This item appeared before the Design Review Committee on November 30, 2016. At that meeting issues were raised about the building design and the Committee requested that the project return to the Committee. Staff requests that the Design Review Committee receive public testimony and provide comments on the revised design.

CITY OF OAKLAND DESIGN REVIEW COMMITTEE

Case File: PLN16295
Applicant: CP VI Franklin, LLC
Address: 1314 Franklin Street
Zone: D-LM2, D-LM-3, D-LM-4

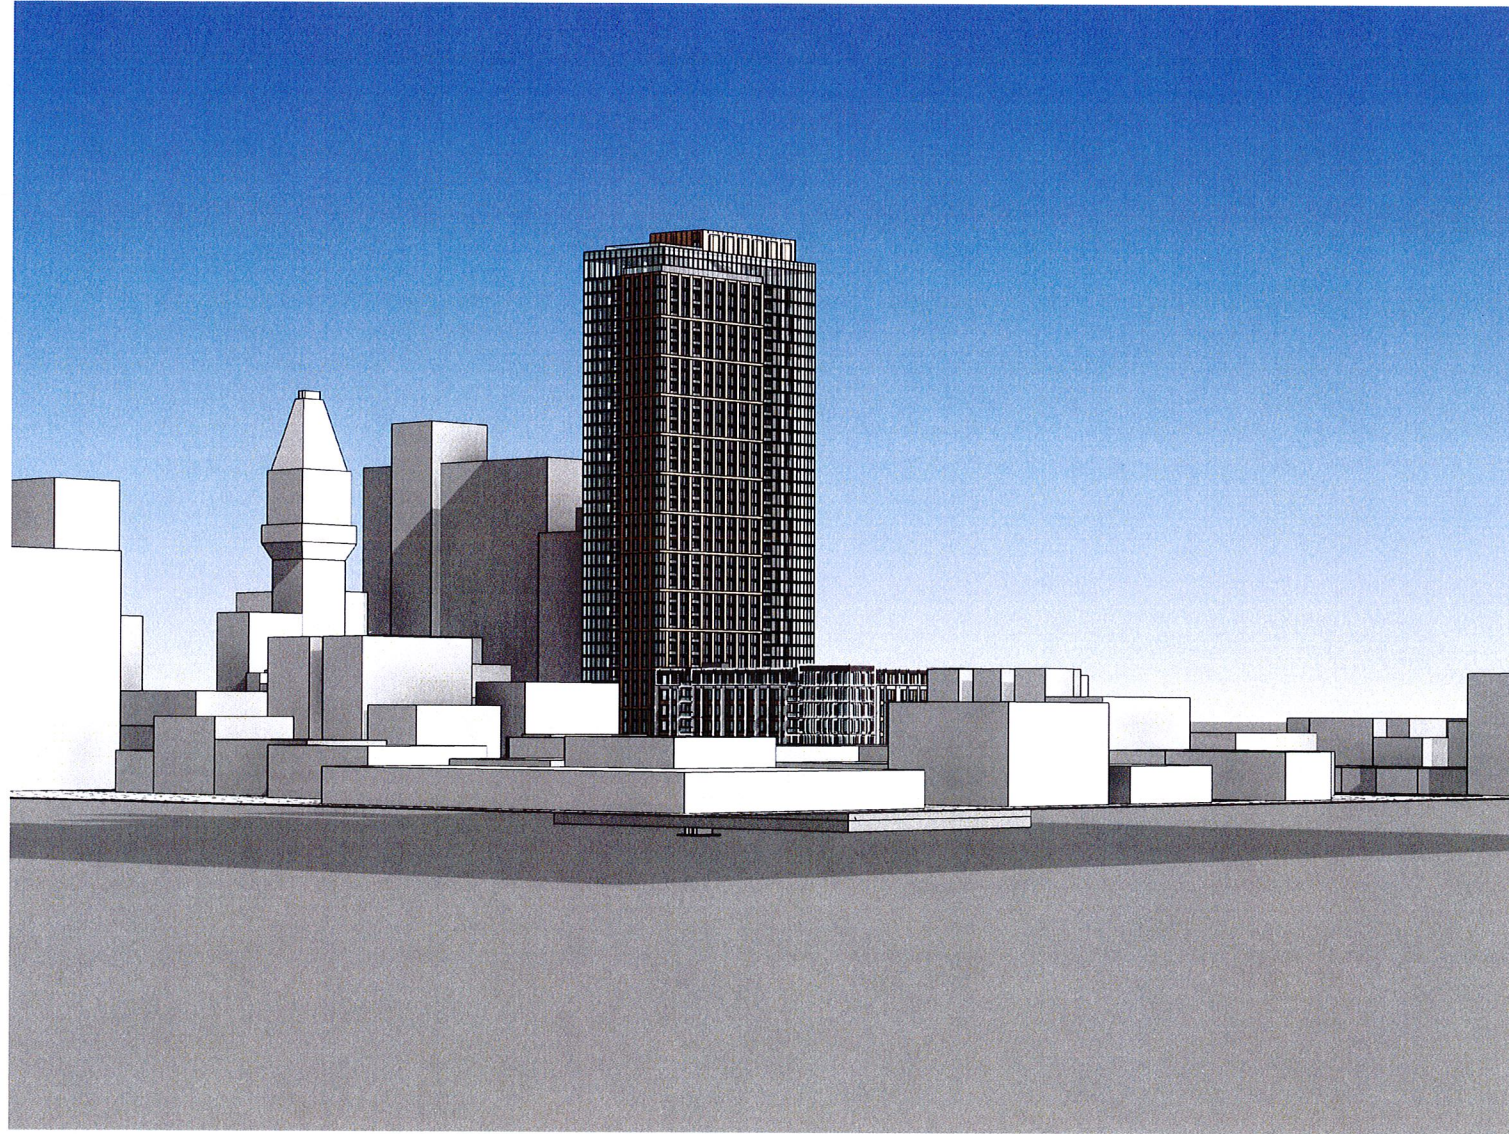
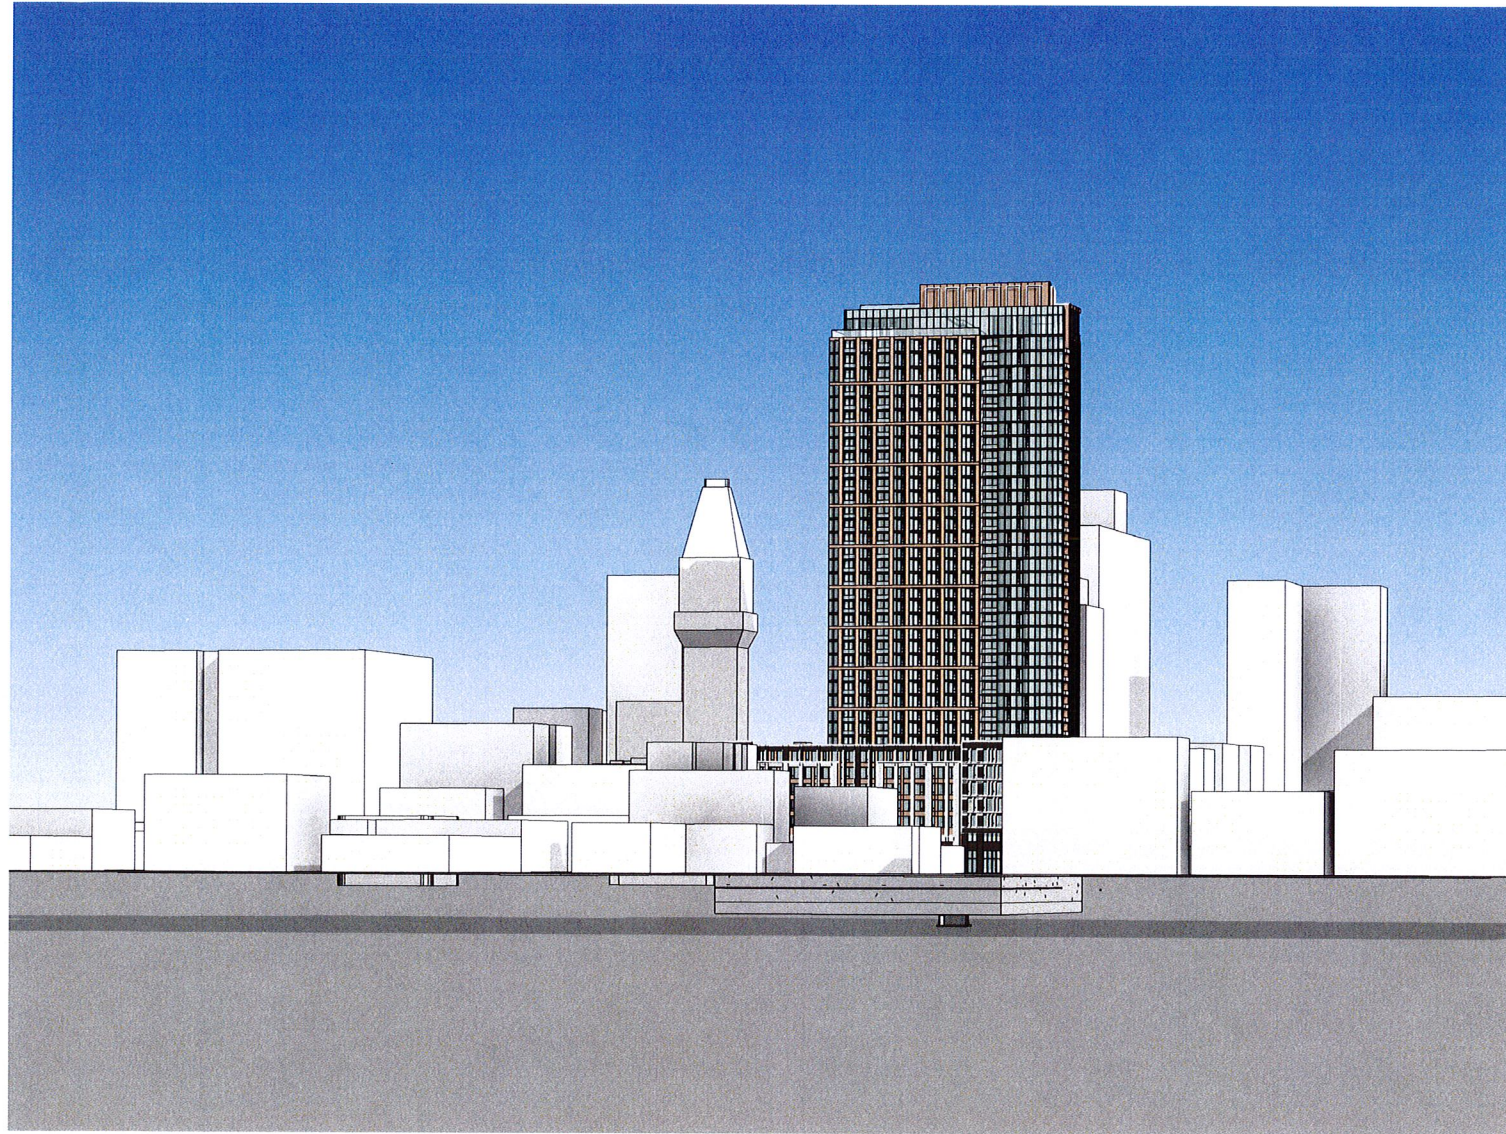
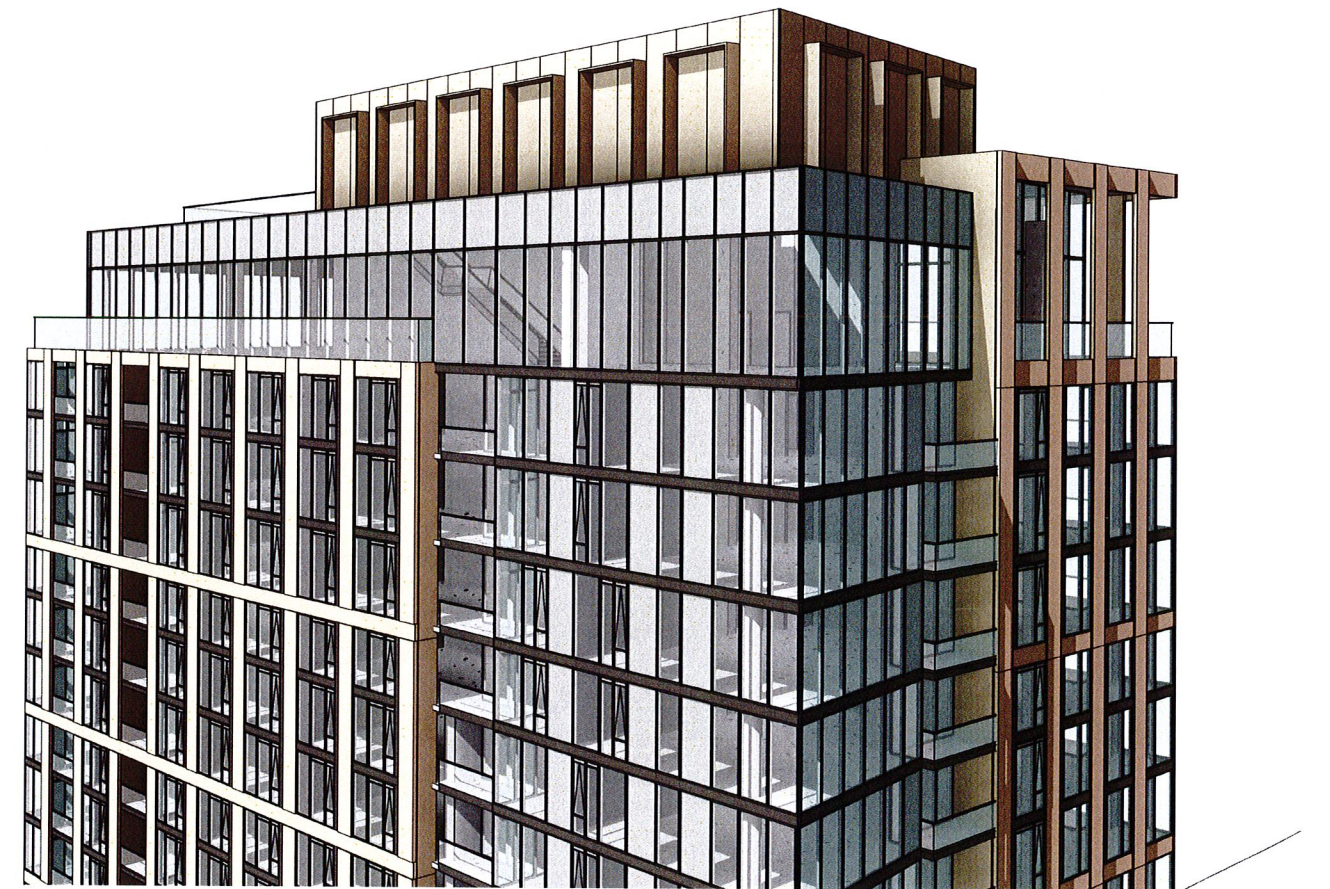
- Study a visually recognizable / sculptural “top” of high rise.

ELEVATION ANALYSIS

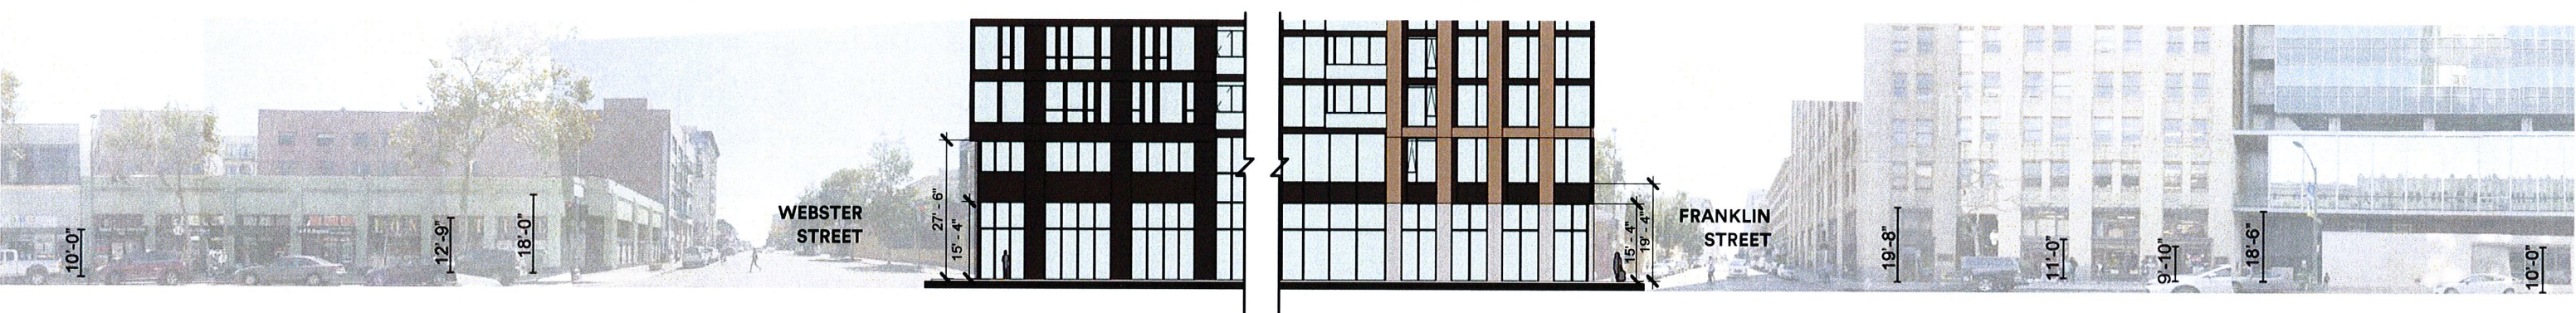
- Study a visually recognizable / sculptural "top" of high rise.

- Scale of tower base should relate to adjacent buildings study bringing the "base" up to the third floor the first residential level would read as part of the base.

- Study bringing grid down to the ground floor to create a rhythm on the glazed storefront. Further study retail expression at podium.

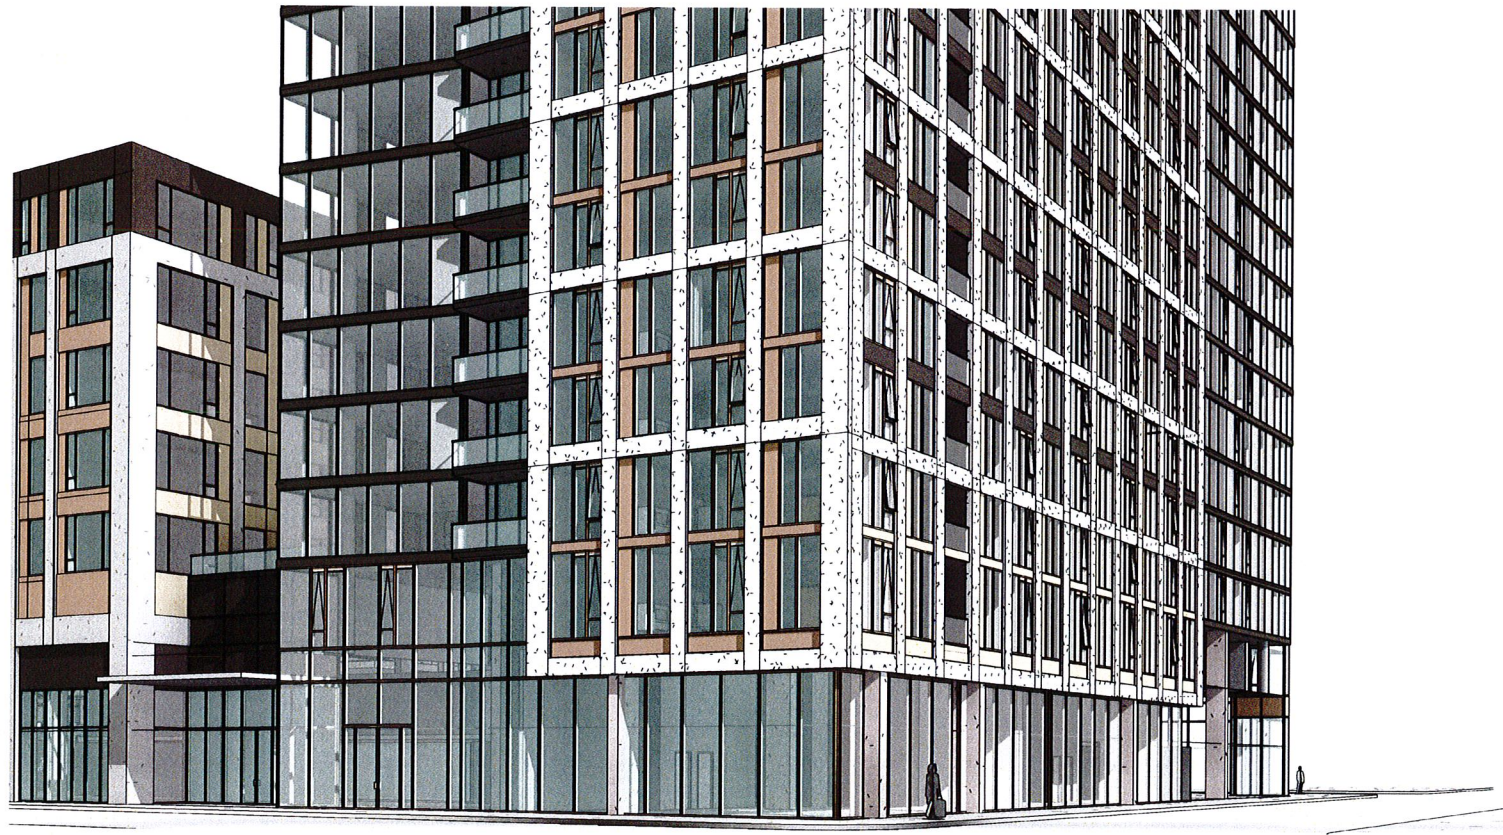
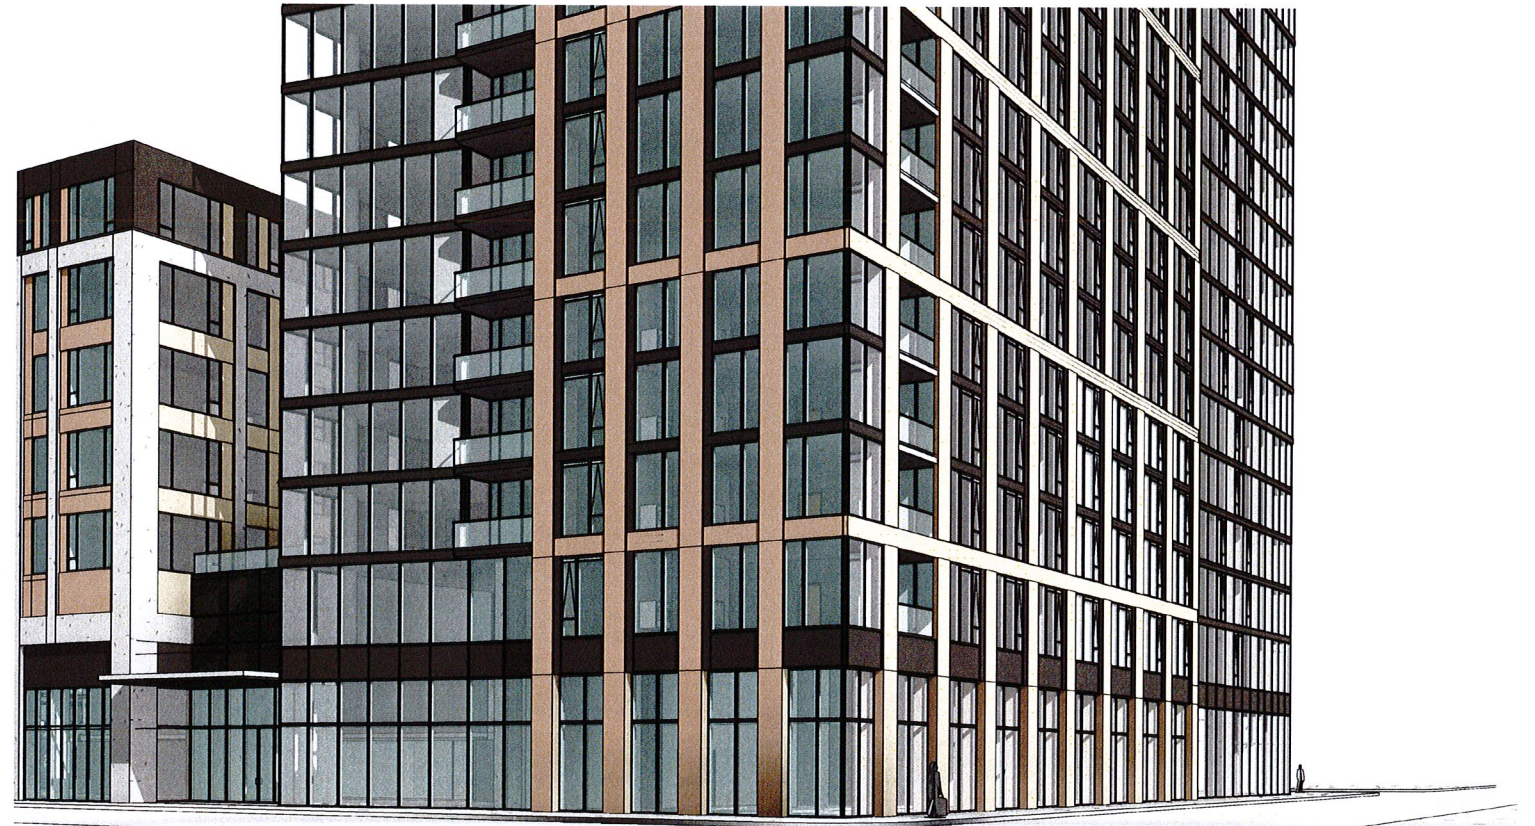
- Need modulation and relief on the podium elevations, is currently too rigid. 3rd floor should feel part of the residential expression.
